# SUBMISSION OF OWNERS CORPORATION ONE DARLING HARBOUR

View Sharing- Dr Richard Lamb

Figure 1
Principle for more appropriate view sharing
(Adapted from part of Page 3, FJMT Supplementary Architectural Design Report)

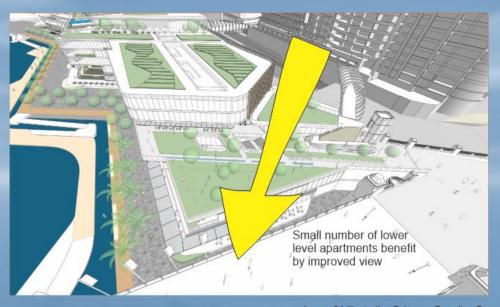
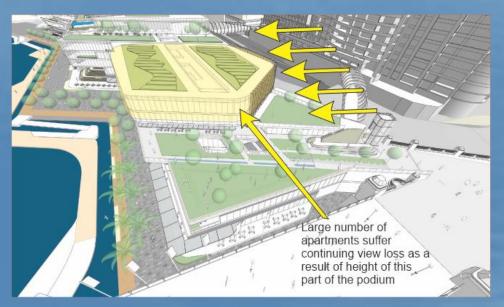
#### Why the podium is too high

Diagram shows how the northern podium causes increased view loss to One Darling Harbour

- The lower podium in the proposed Guardian Square area is a guide to an appropriate heigh for the podium
- The benefits should be extended by continuing the lower podium further south as far, at least, as the next proposed step up in the podium to the south
- If the proposed green roof envisaged in the Draft Development Consent is to be approved, it is imperative, to avoid conflicts with the EARs in Part C, that the podium is lowered.
- In this way, landscape can be added to the additional public open space that will be of public benefit without being in conflict with reasonable view sharing.
- Reconsideration of the height of this part of the podium could provide a satisfactory outcome for One Darling Harbour in terms of view sharing
